**Landscape and Visual (L&V) Monitoring Report for
Harbour Area Treatment Scheme Stage 2A
(Operational Phase) (May 2022)**

Report No.: OT_2022007

Landscape and Visual Impact Assessment Checklist for Site Audit – North Point PTW

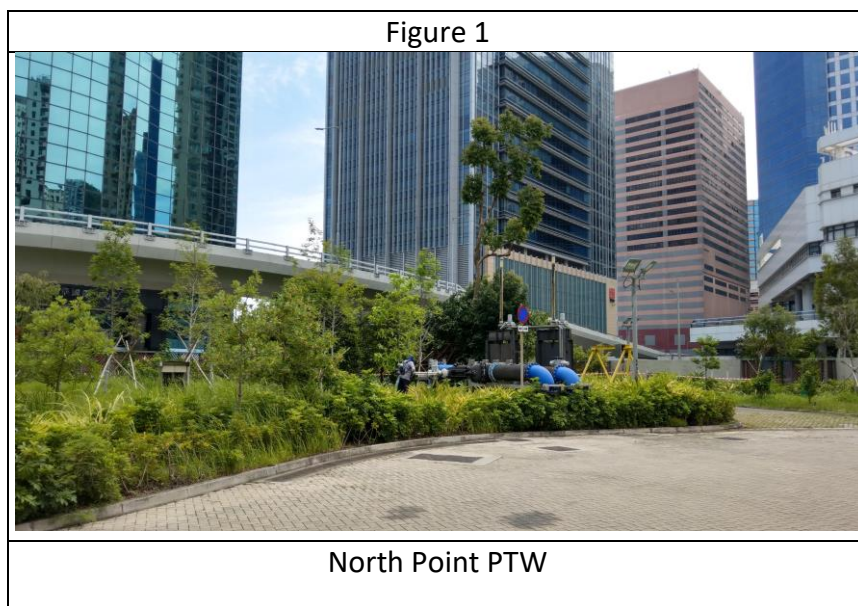
- Contractor was reminded to carry out proper maintenance to plantings and was recommended to increase the frequency of watering.

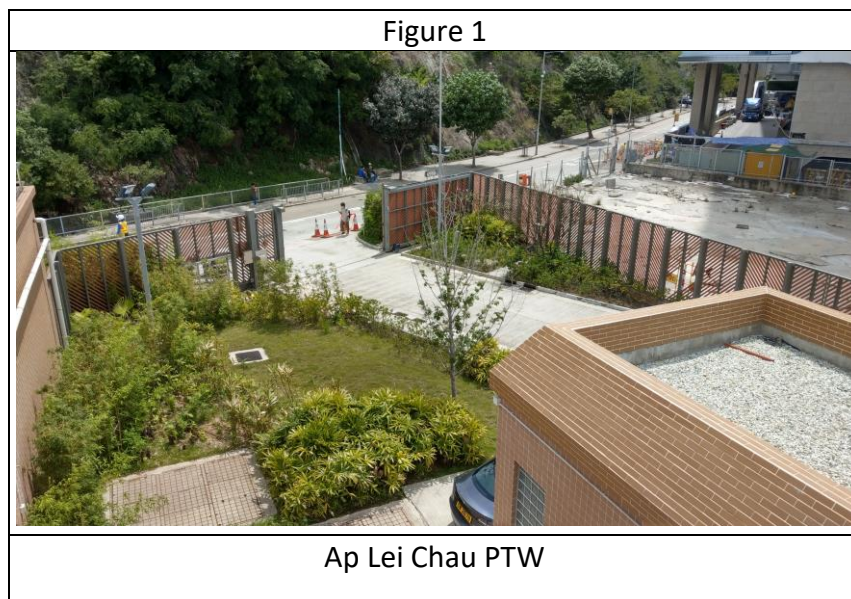
- Contractor was reminded to carry out proper maintenance to plantings and recommended to increase the frequency of watering.

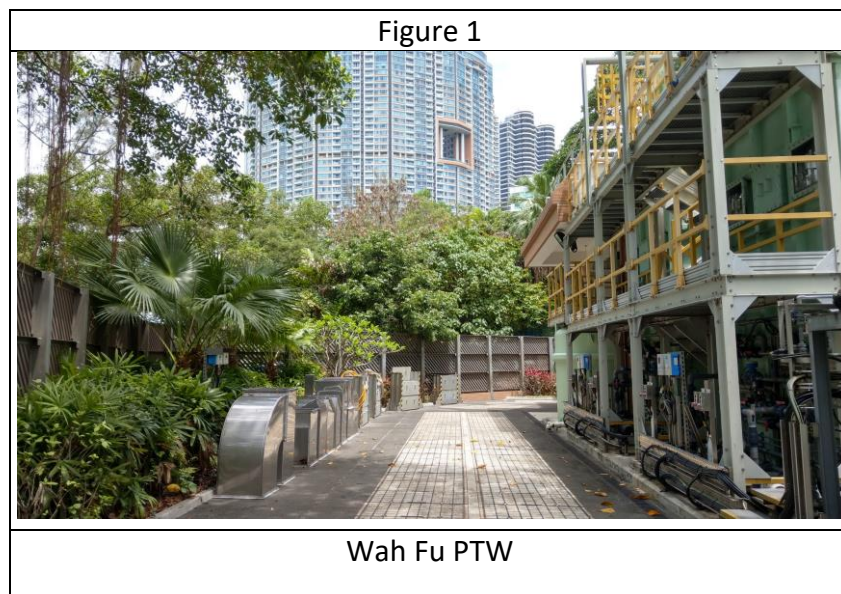
- Contractor was reminded to carry out proper maintenance to plantings and recommended to increase the frequency of watering.

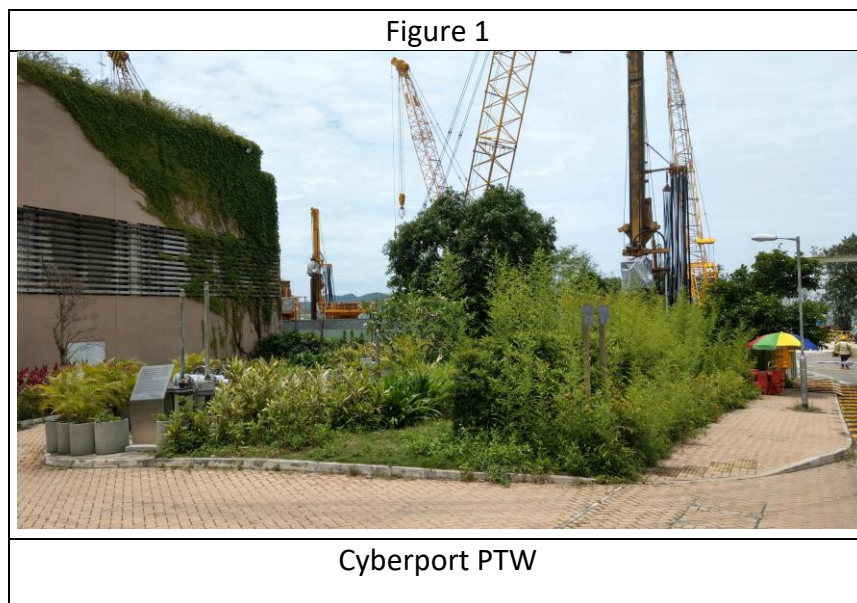
- Contractor was reminded to carry out proper maintenance to plantings and increase the frequency of watering. It is also recommended to increase the maintenance of pot plants.

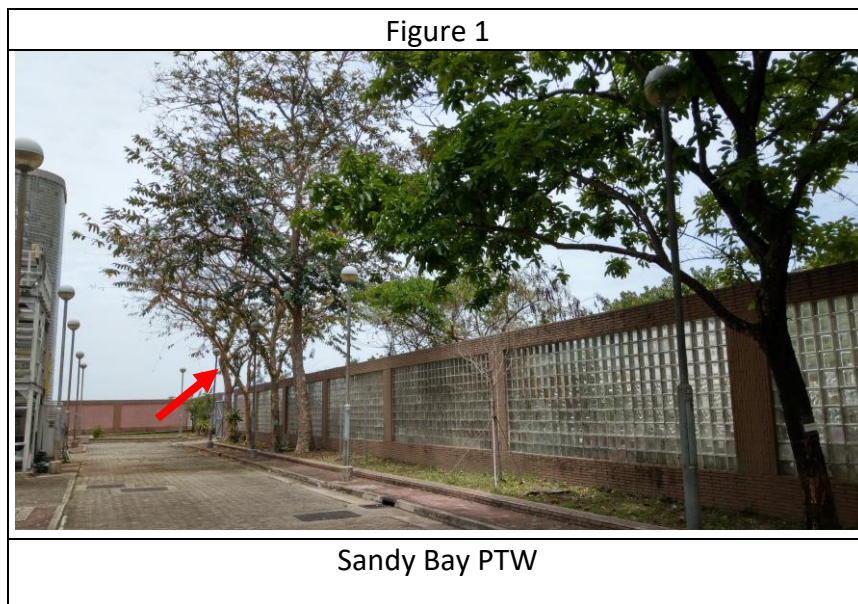
- Contractor was reminded to carry out proper maintenance to plantings and recommended to increase the frequency of watering.
- It was noted that leaves shredded and foliage's colour turns yellow for trees at inner side as shown in Figure 1. Continuous monitoring of the tree condition is required.

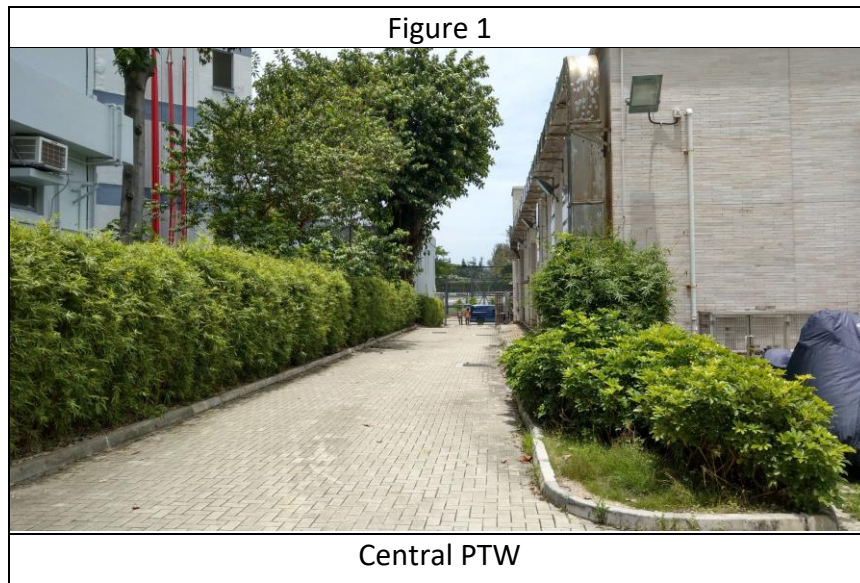
- Contractor was reminded to carry out proper maintenance to plantings.

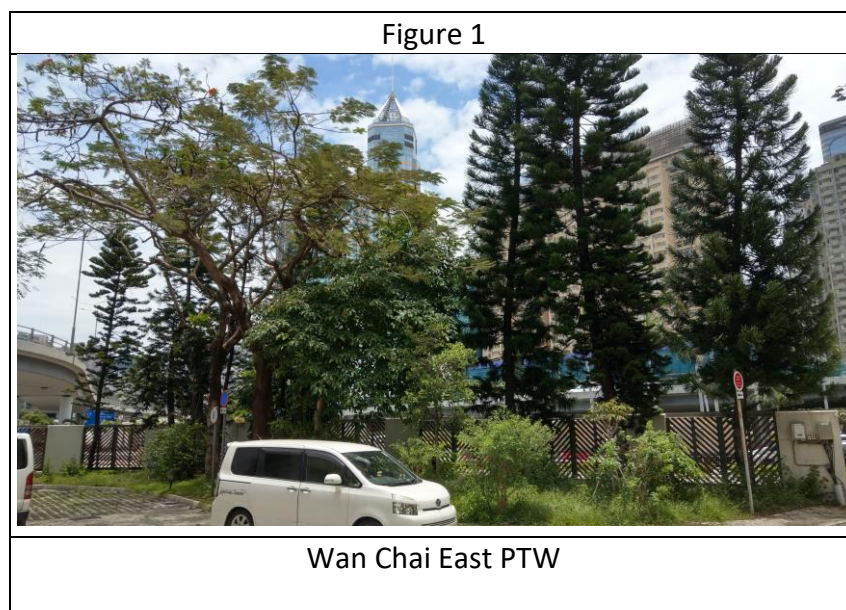
- Contractor was reminded to carry out proper maintenance to plantings and recommended to provide adequate protection to trees adjacent to works area.
